REFERENCE: **B004-19 BPUB Remodel of the Existing Administration Building Restrooms Renovations Project**

## ADDENDUM NO. 01

**BPUB Restrooms Renovation Project**  
**BROWNSVILLE PUBLIC UTILITIES BOARD**  
ERO Project No.: 16002A

## **ADDENDUM 1 NARRATIVE**

BPUB Restrooms Renovation Project Addendum #1 - Exhibit "A"

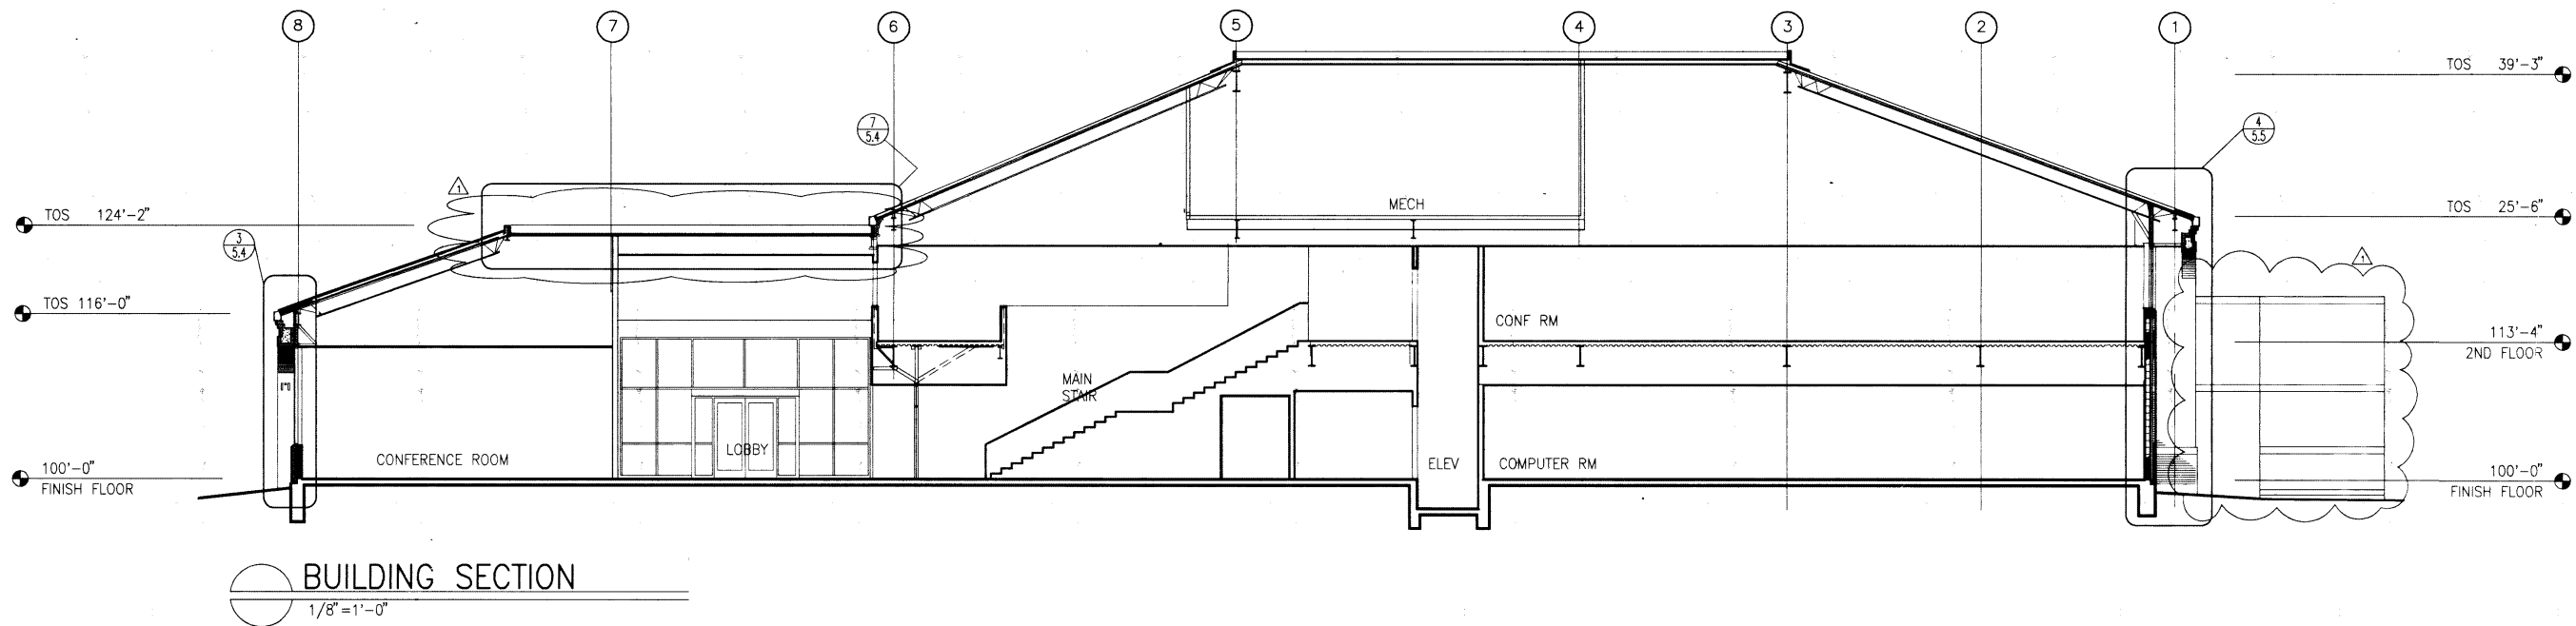
- Item No. G06. CLARIFICATION – Contractors are hereby notified of the attached **Exhibit "A"** depicting Staging Areas and placement of portable restroom facility. Upon completion of the project, Contractor shall be responsible for restoring all grass and landscaping impacted (approx. 100' x 100' area to be sodded). Grass and/or Sodding shall not be paid for directly but be subsidiary to all other bid items.

10 DEMOLITION FIRST FLOOR RESTROOM PLAN - LOBBY  
1/4" = 1'-0"

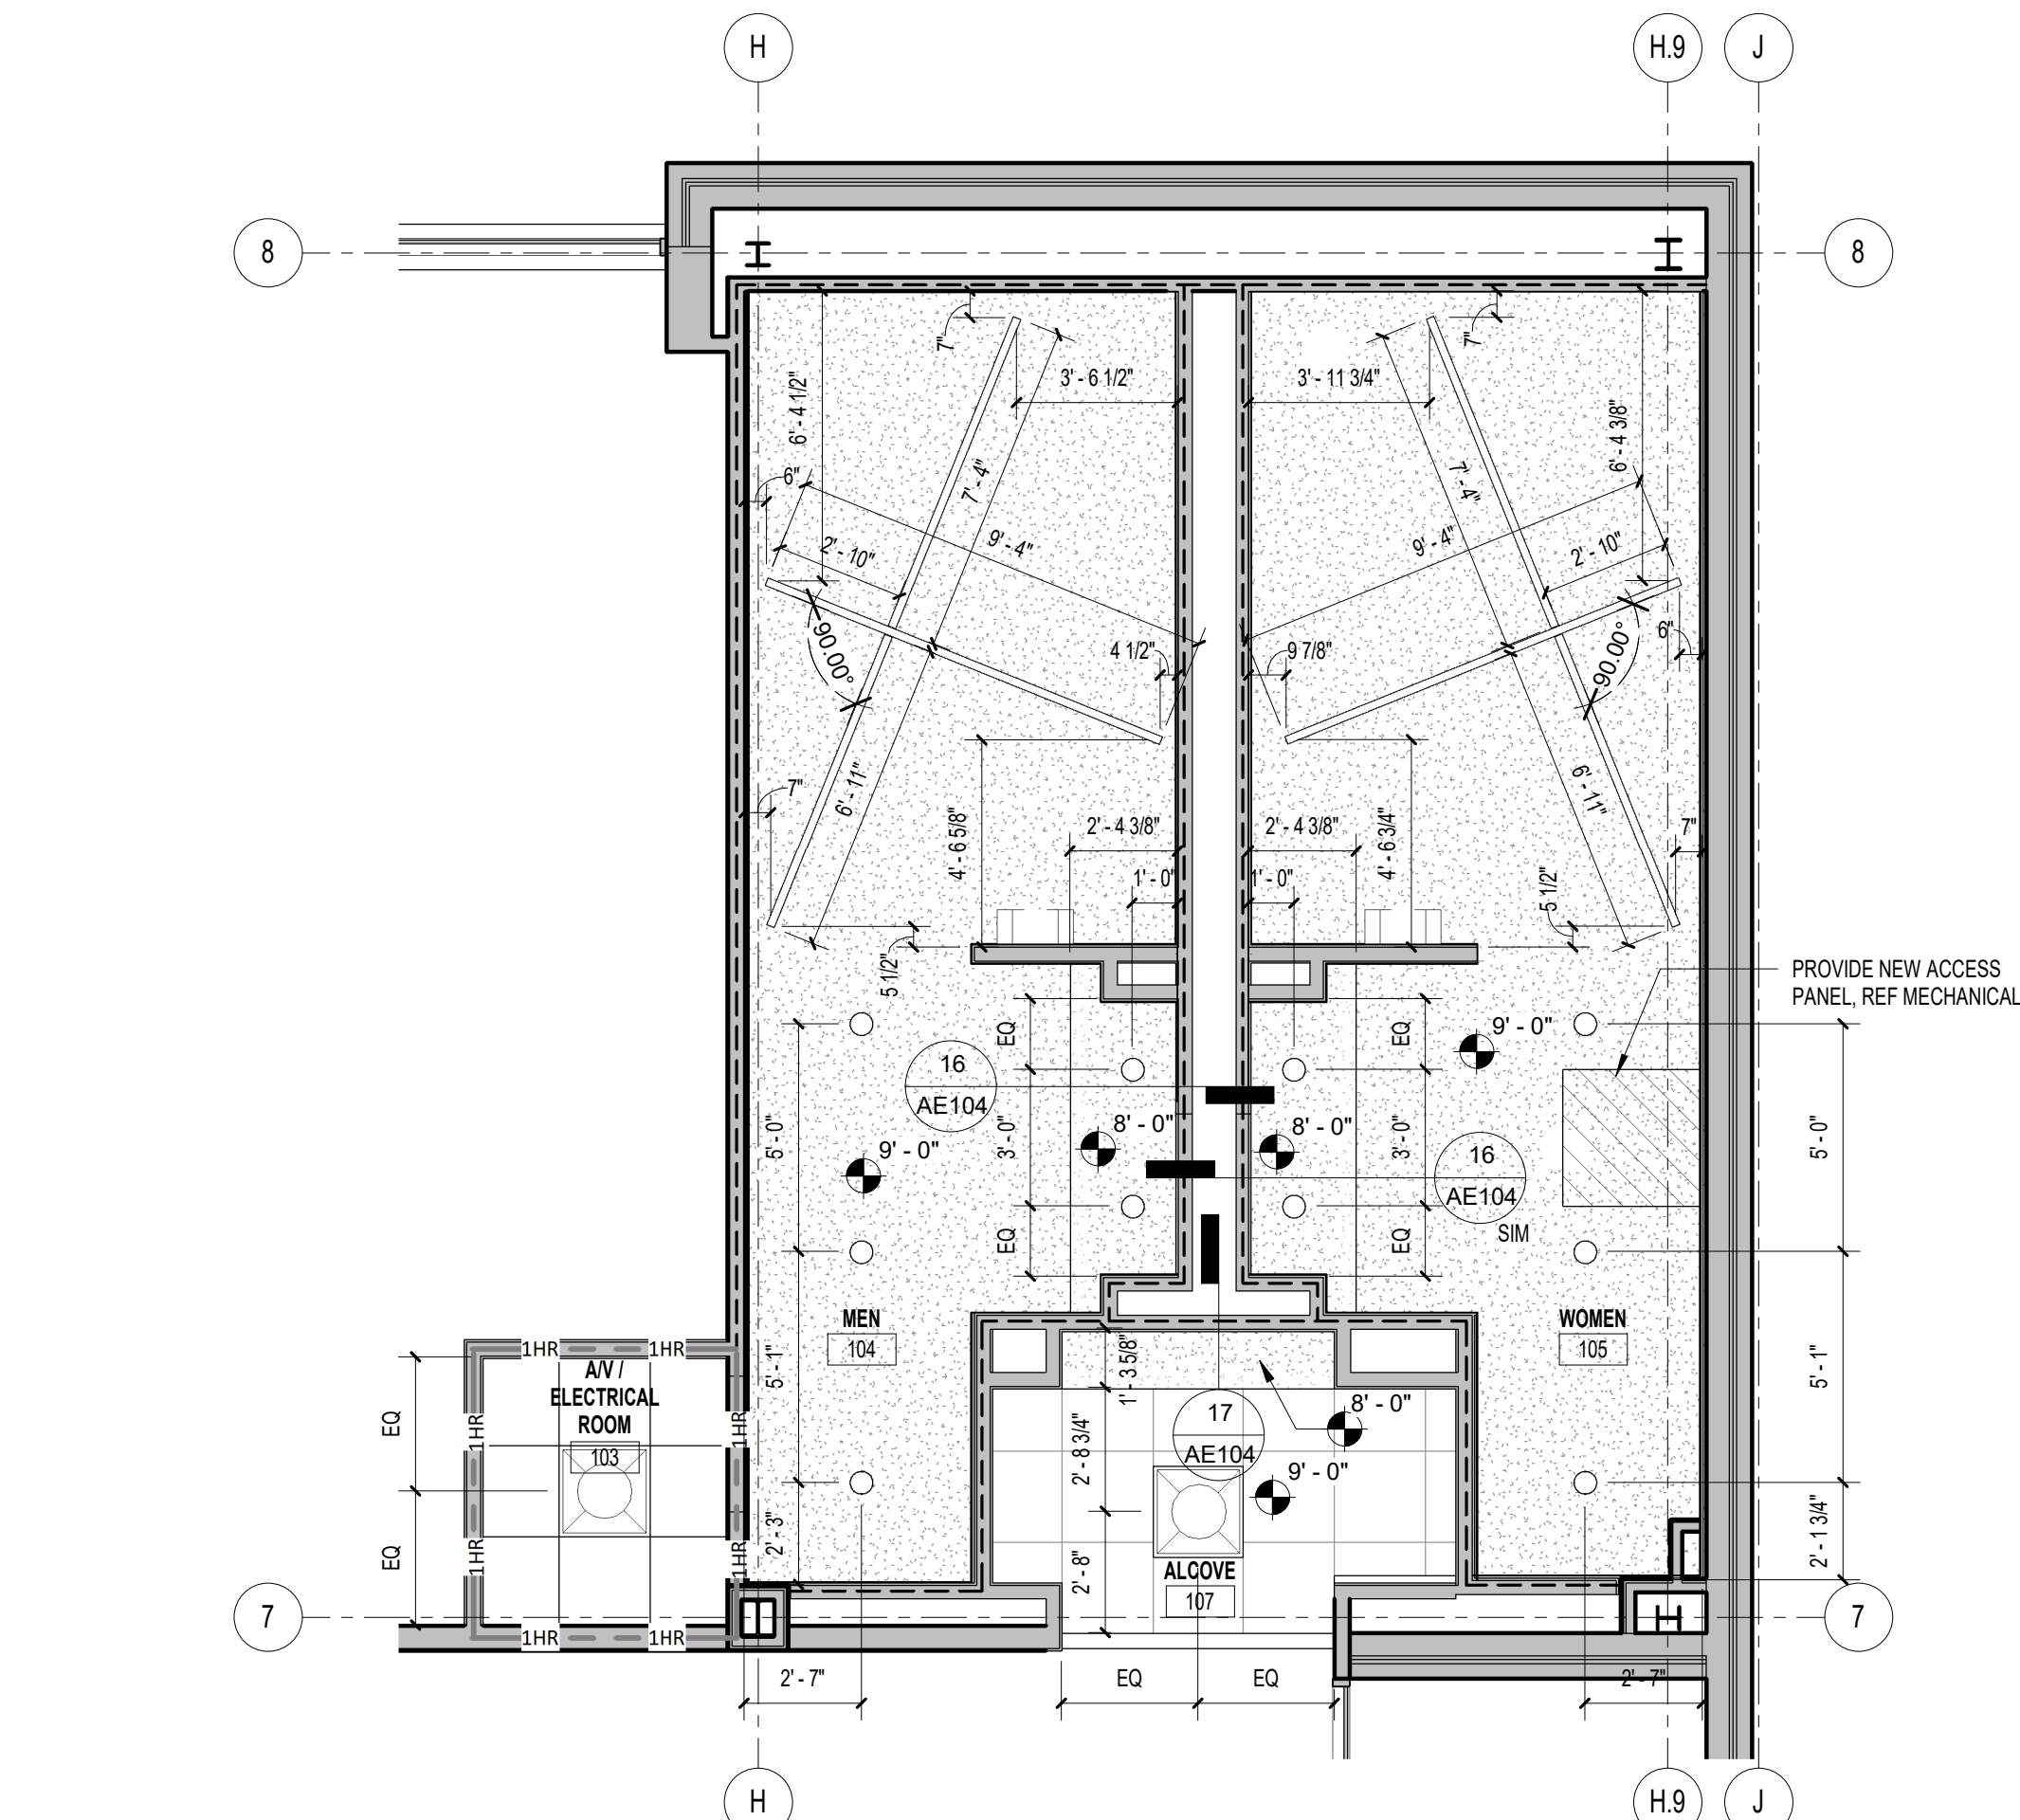
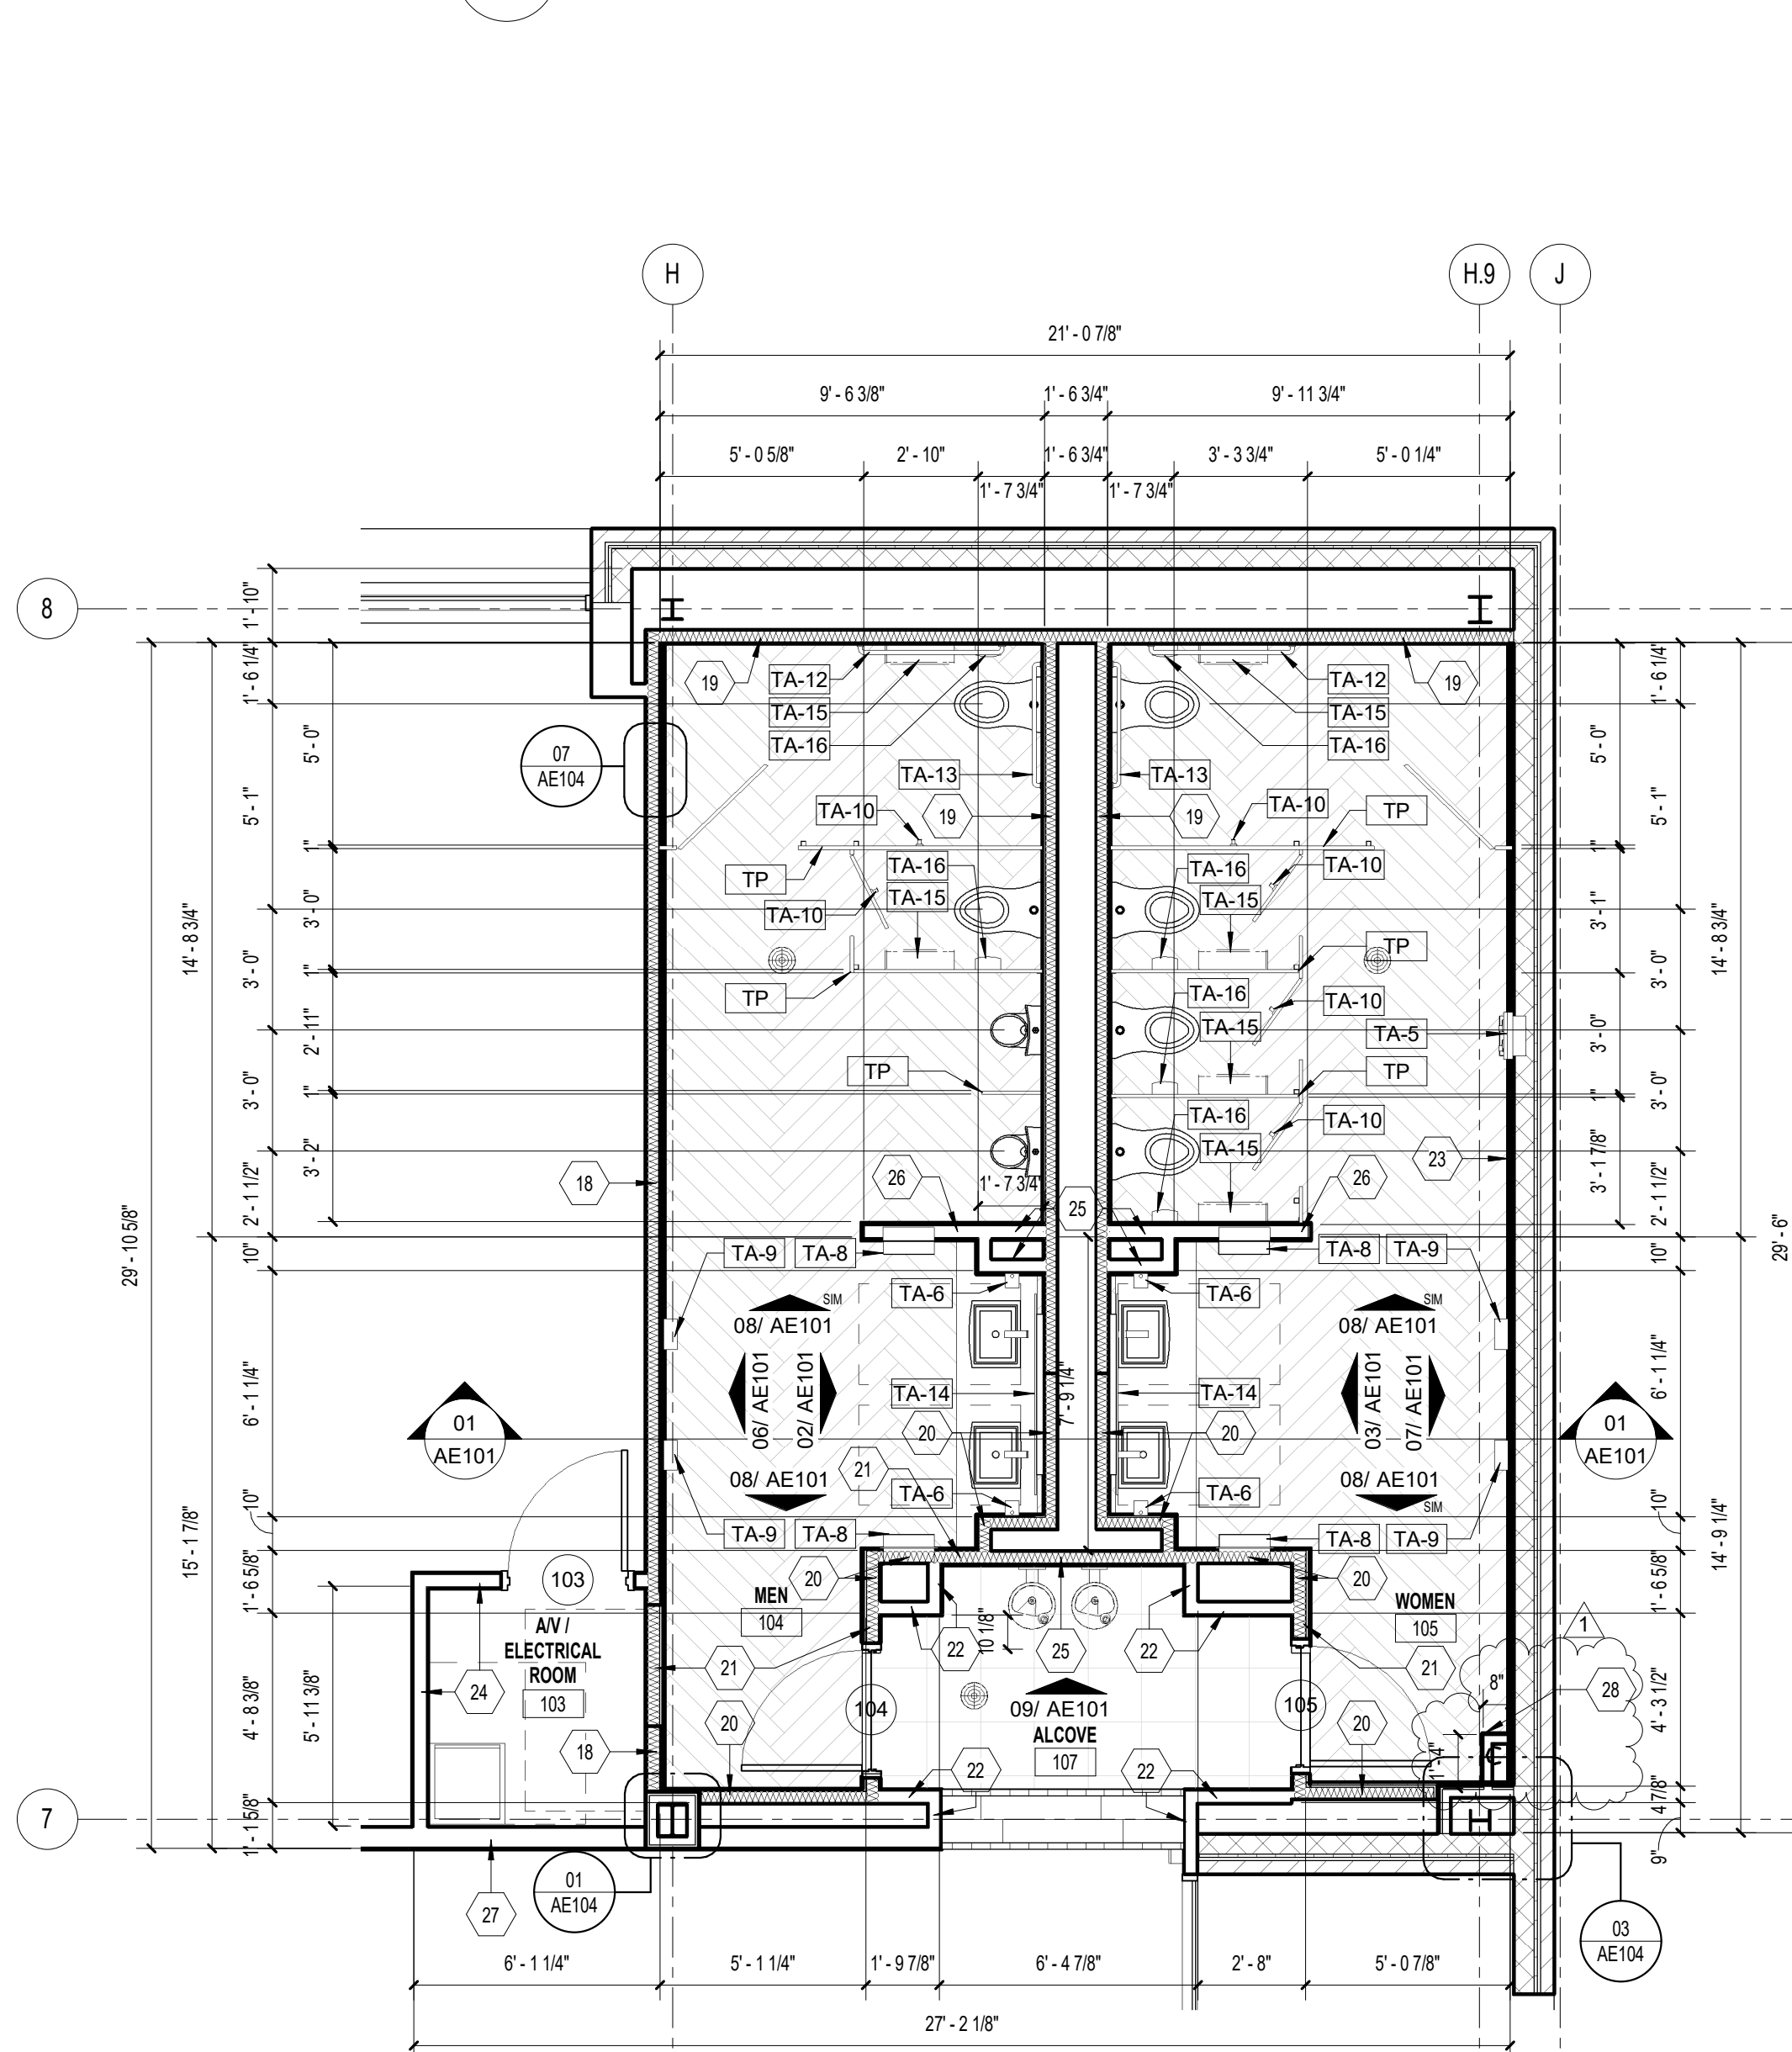
- Item No. P01. Sheet **AE101 – 1ST FLOOR LOBBY RESTROOMS**. Replace sheet in its entirety – Sheet has been revised to show added Demolition Keynote and revisions on Detail 10, and Detail 11.

FLOOR PLAN KEYNOTES
18. EXISTING PARTITION: PARTITION TO DECK. REPLACE ANY DAMAGED OR CORRODED METAL STUDS AND PROVIDE BATT INSULATION AS NOTED IN FLOOR PLAN. PROVIDE ONE LAYER OF 5/8" GLASS-MAT, WATER-RESISTANT BACKING BOARD OVER ONE LAYER OF 5/8" GYP. ON OCCUPIED SIDE. PROTECT EXISTING GYPSUM BOARD ON OPPOSITE SIDE. @ FIRE PARTITION - UL DESIGN 419 & TREAT AS PER HLT FIRESTOP SYSTEM HW-0-042 (UL DESIGN 2076).

28. FIRE SPRINKLER TEST DRAIN PIPE. FURR-OUT EXISTING FIRE SPRINKLER TEST DRAIN PIPE. FIELD VERIFY EXISTING CONDITIONS/DIMENSIONS TO MAINTAIN A MINIMUM OF 48" BETWEEN DOOR AND FURR-OUT. PROVIDE GRADE PAINTED LOCKABLE ACCESS PANEL FOR VALVE.
